J2025-0107
PSP2025-0006
Revision #2
Received 6/13/2025

Site Plan Review

Reviewed for compliance with City Ordinance, Building and Fire Codes
Conditions and mark-ups noted throughout plan set must be addressed prior to final approval

OWNER/PROPRIETOR
PINE TRACE GOLF COURSE
3600 PINE TRACE BOULEVARD
ROCHESTER HILLS, MICHIGAN 48309
MICHAEL BYLEN
MICHAELBYLEN@GMAIL.COM
248-852-7100

LANDSCAPE PLAN

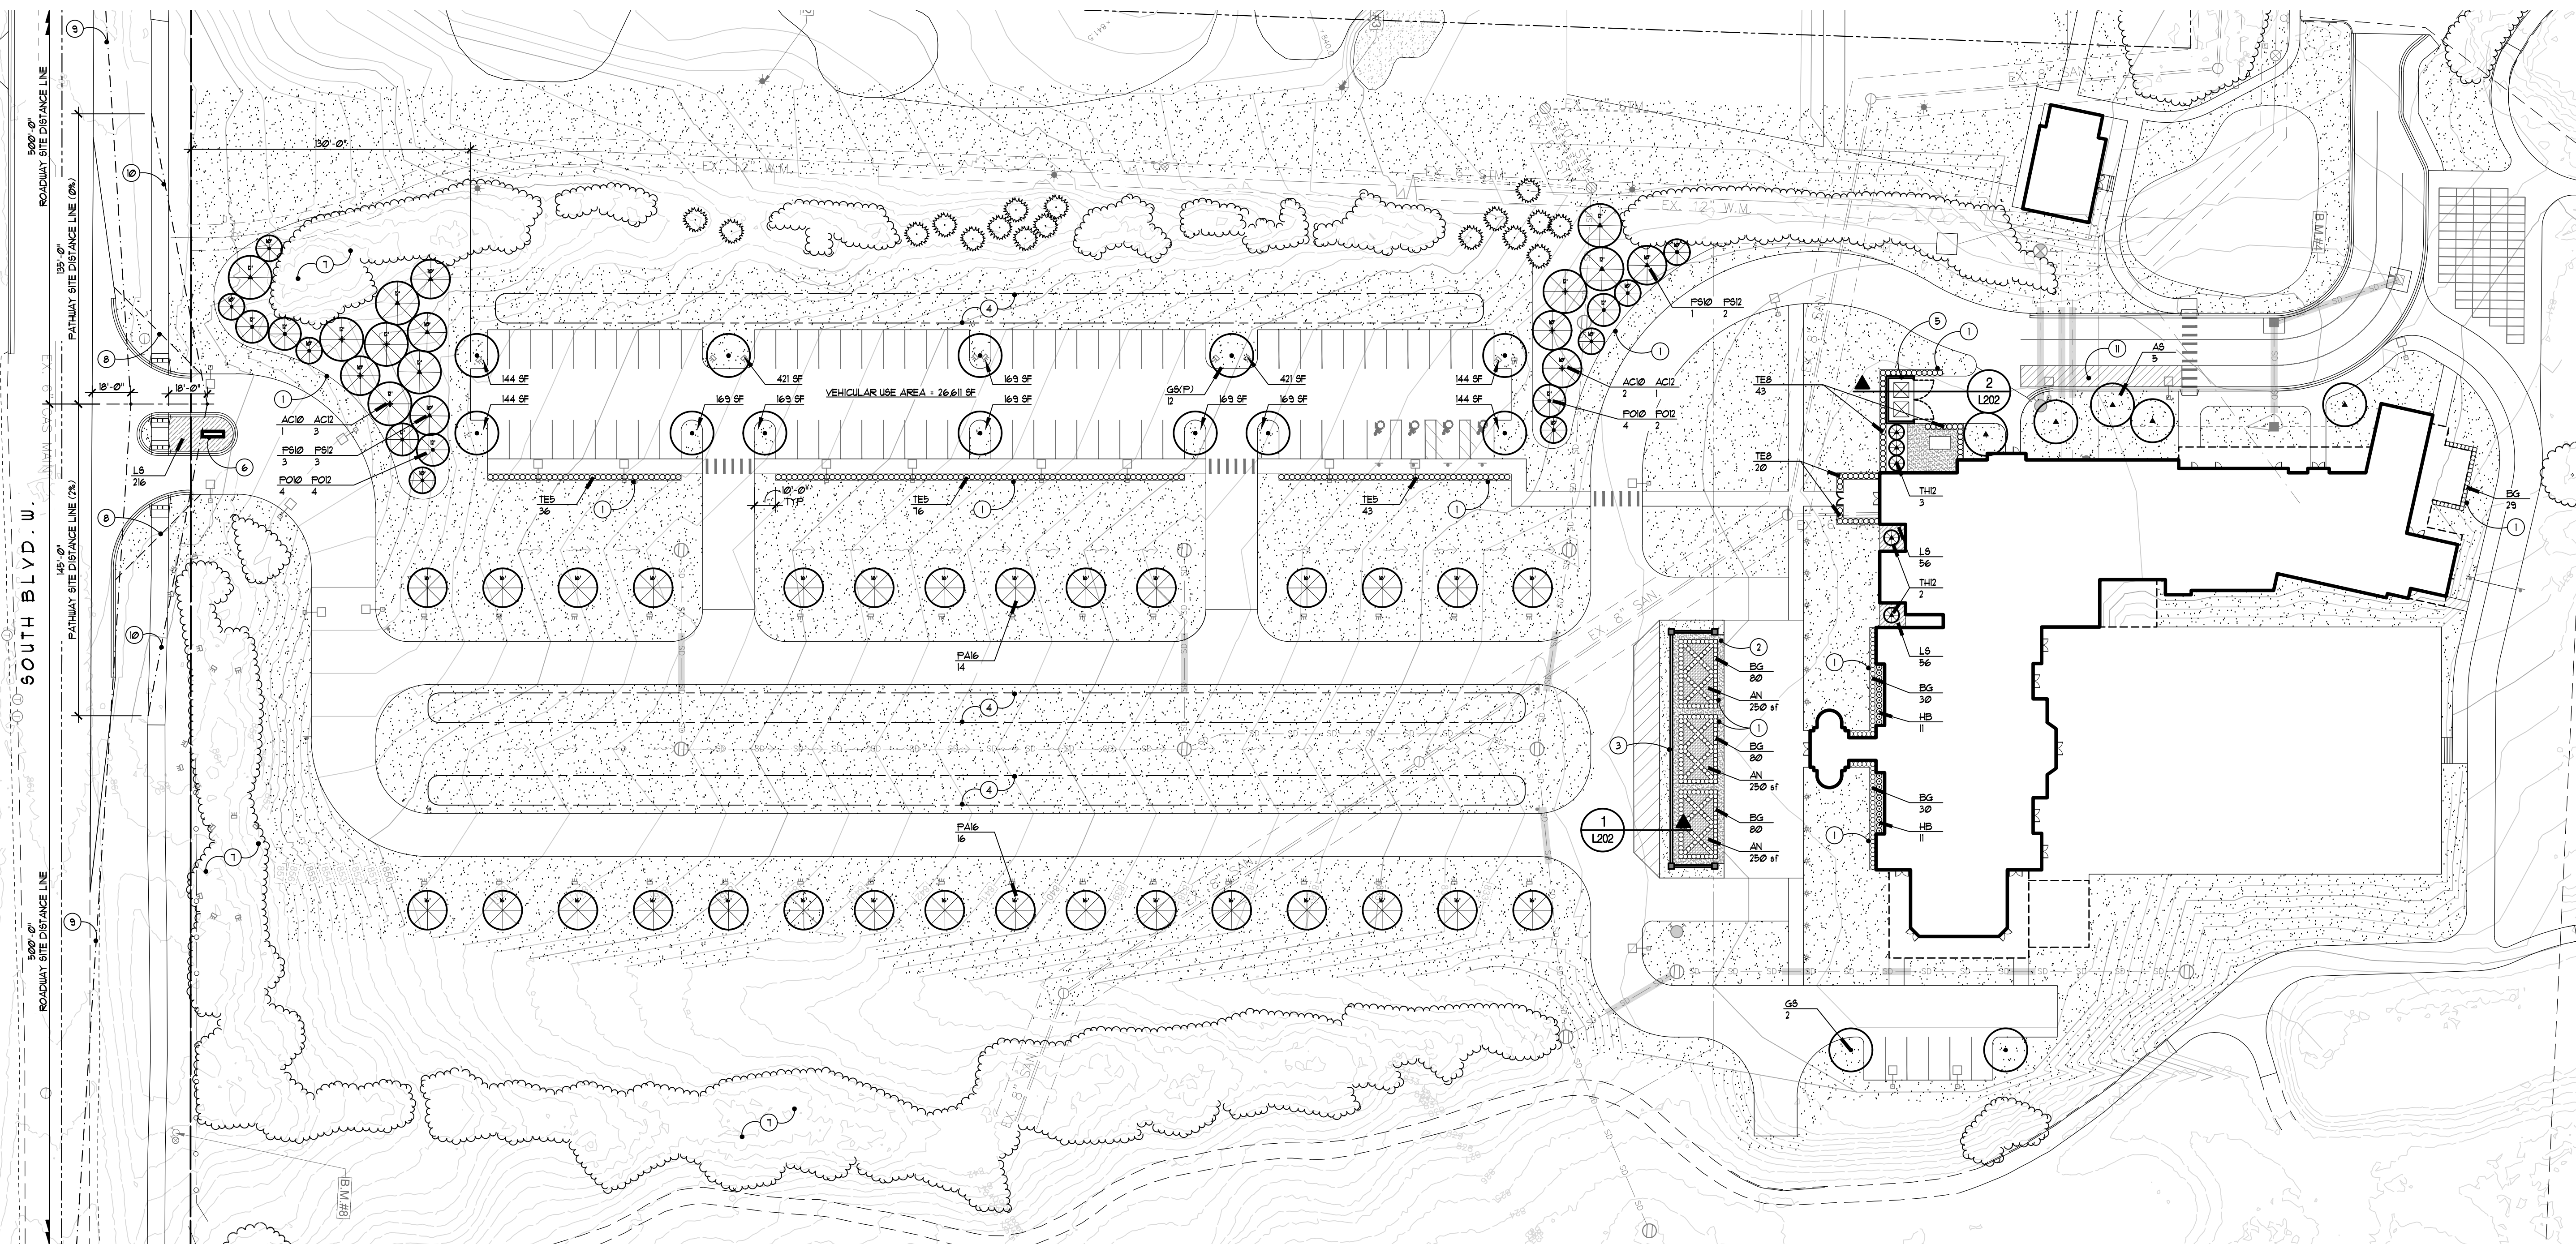
Replacement credits and calculations are incorrect. See comments on L101.
